**CITY OF BATON ROUGE
PARISH OF EAST BATON ROUGE
DEPARTMENT OF ENVIRONMENTAL SERVICES**

ADDENDUM NO. 5

SUBJECT: **CENTAL WASTEWATER TREATMENT PLANT DEMOLITION PROJECT
CITY-PARISH PROJECT NO. 14-TP-MS-016D**

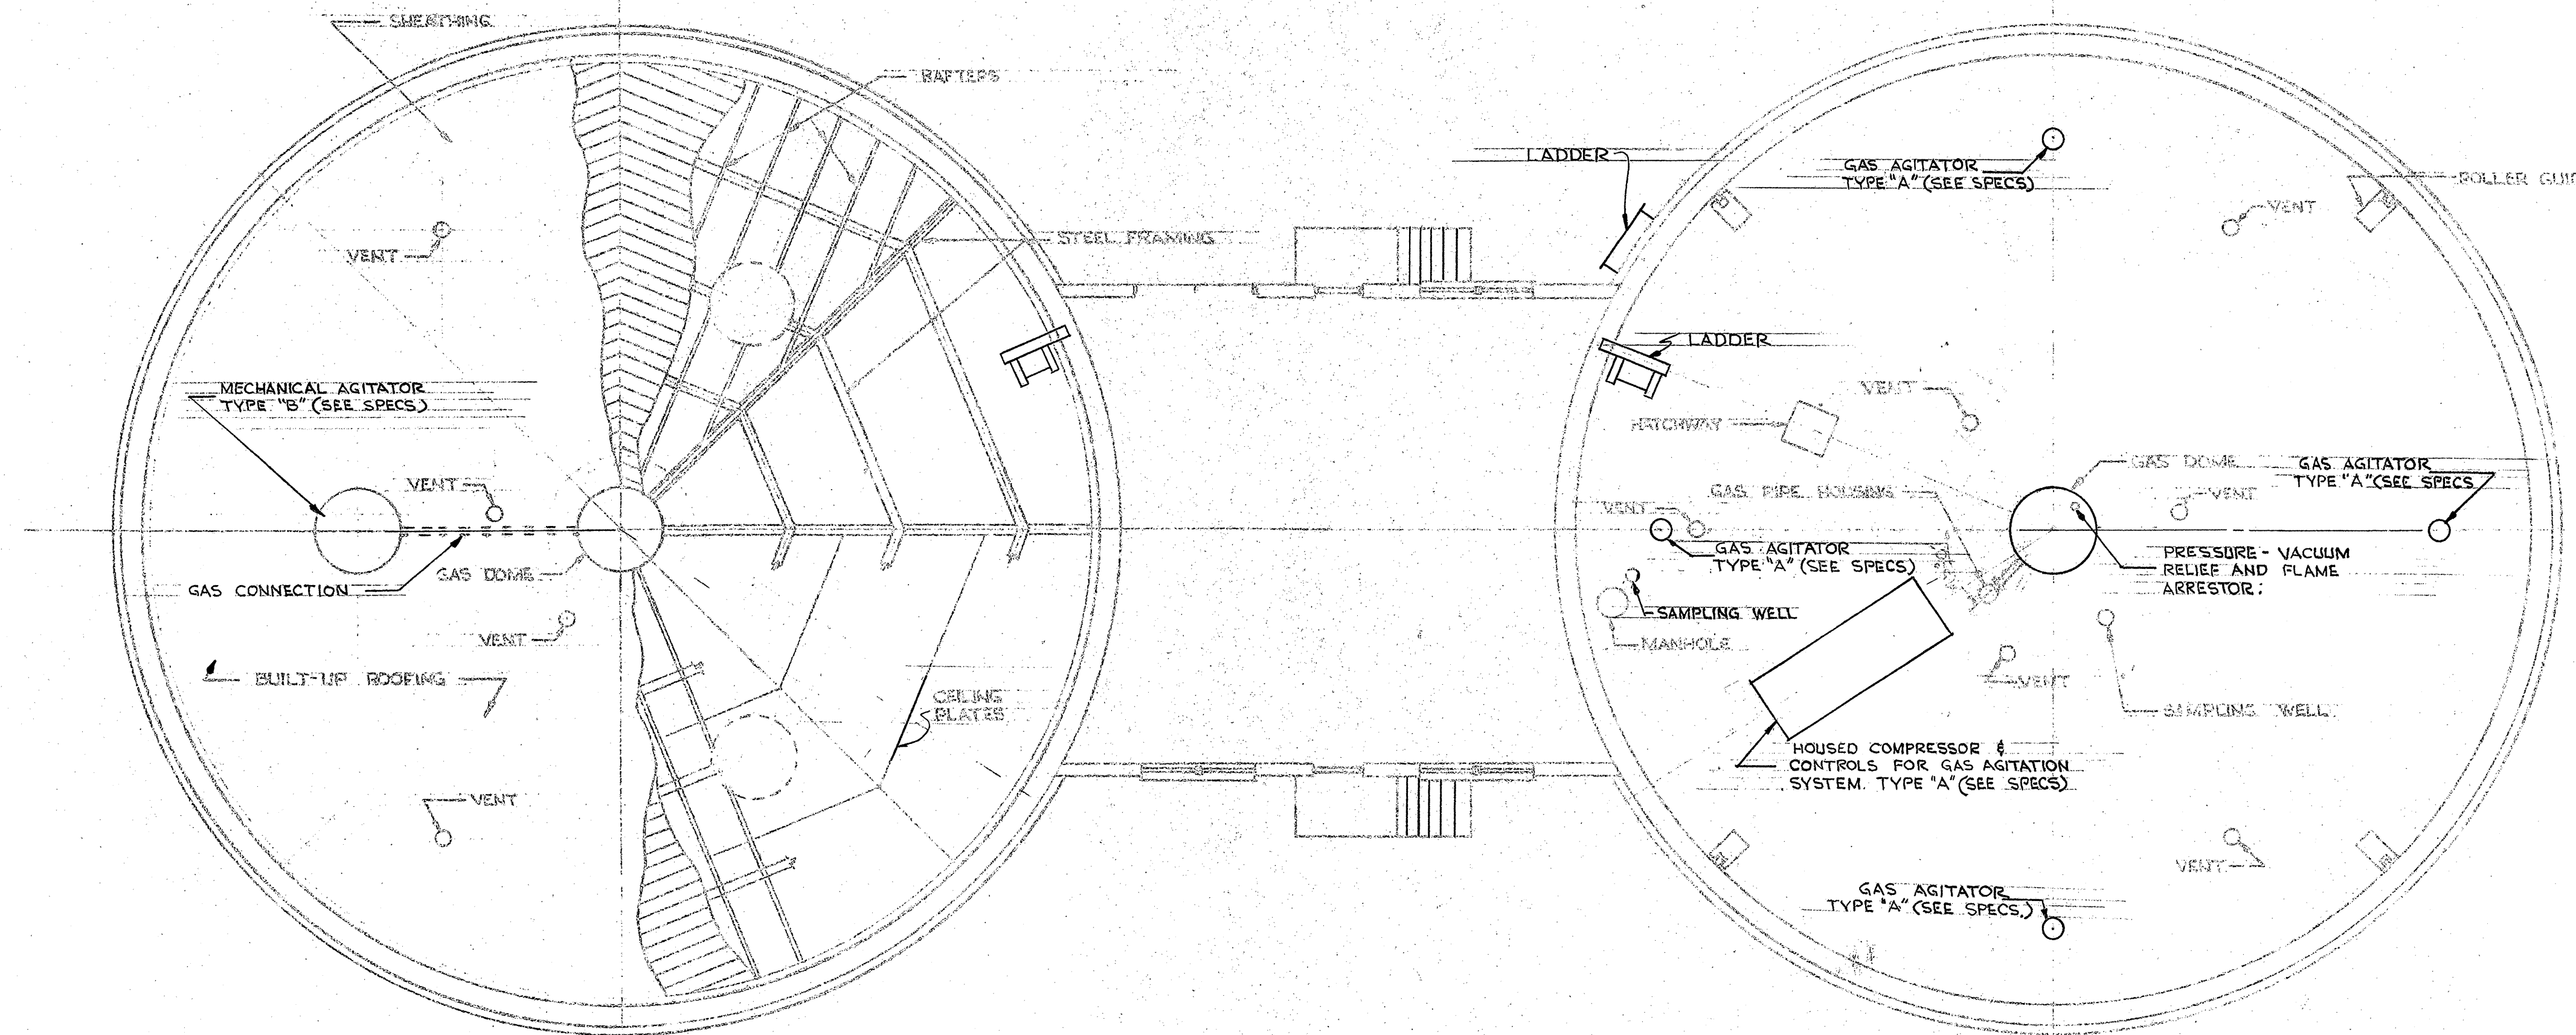
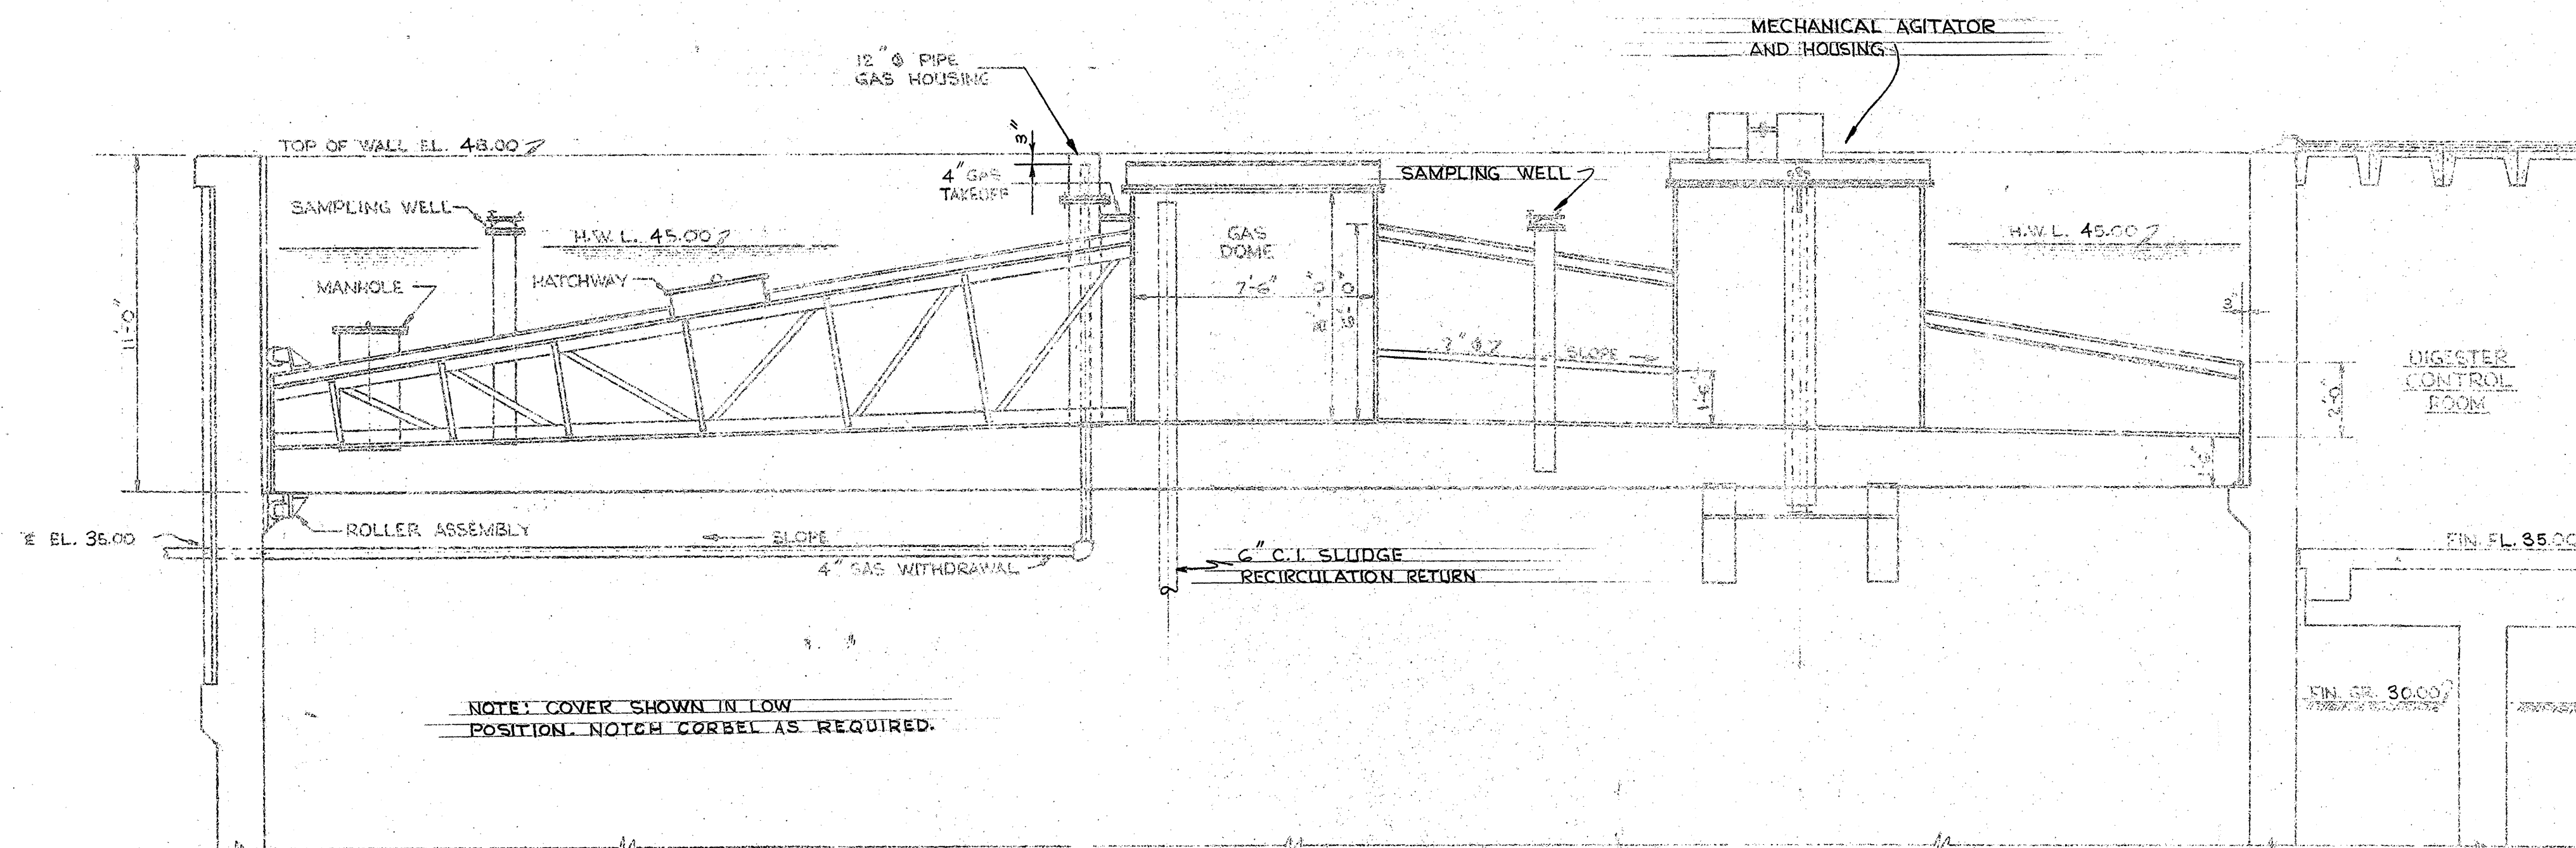
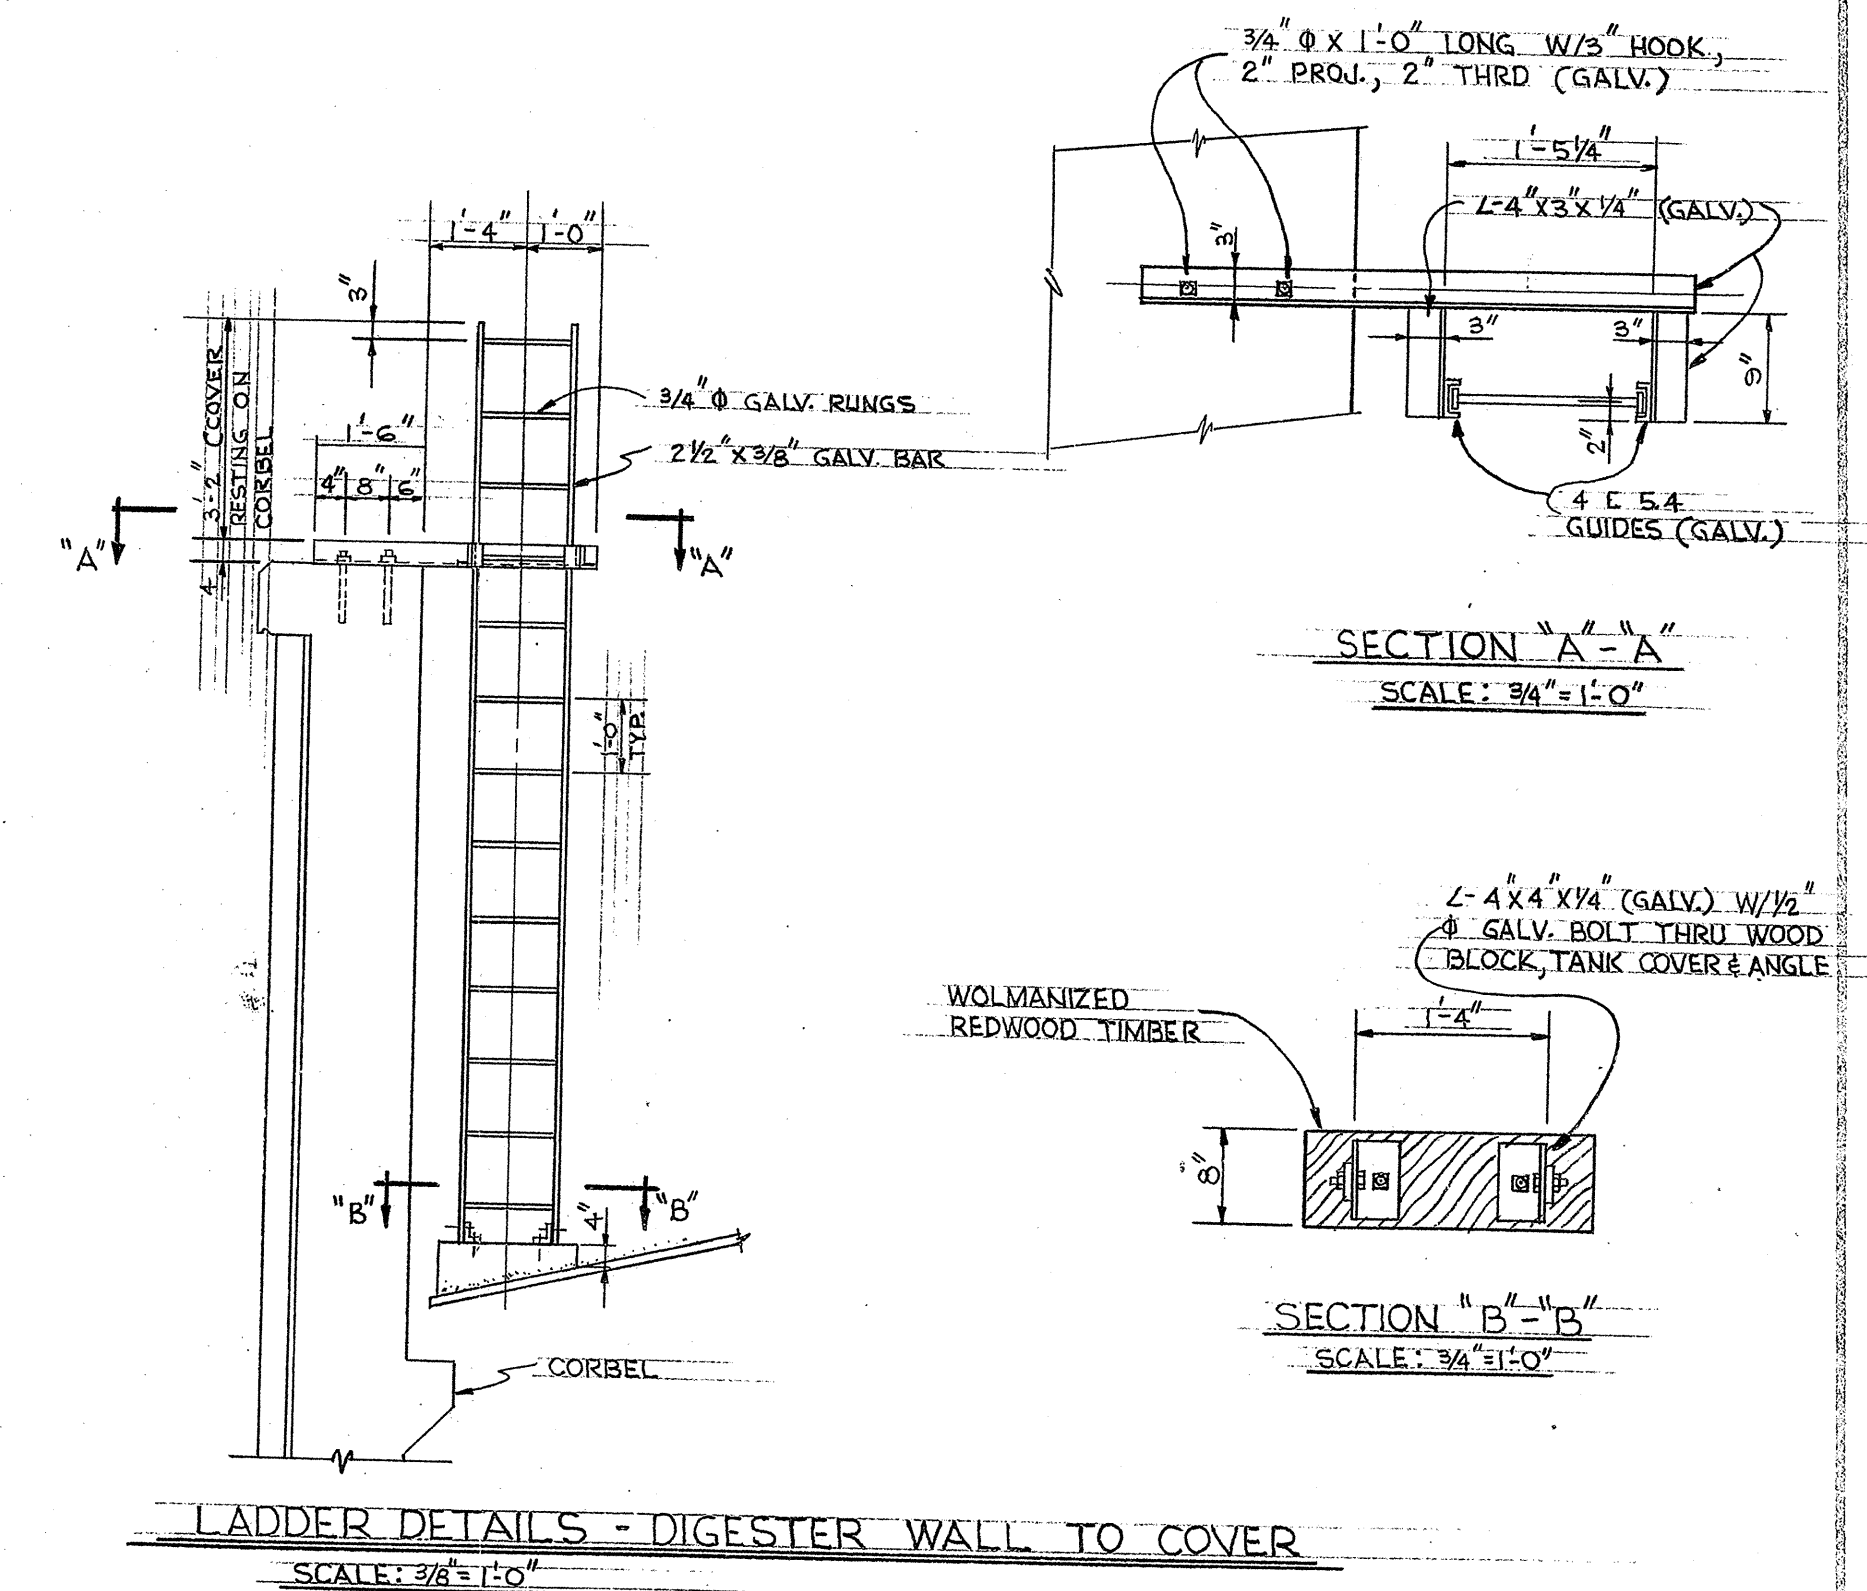
1. Do you know what the cover on the digester tanks is made of? Also, the digestors are shown to be wholly above ground. Only the brick veneer is at grade level. Those tanks are cone shaped and are 17 feet below grade on sides and deeper in the middle. This will likely require more breaking and backfilling.

A copy of the digester cover drawing has been attached to this Addendum for informational purposes only. The hatching for digesters 1-3 was shown incorrectly on the plans. Sheet C-3 has been revised and reissued on this Addendum to denote the digesters are above/below grade. The cut/fill quantities accounted for the below grade portion of the digesters so those did not change.
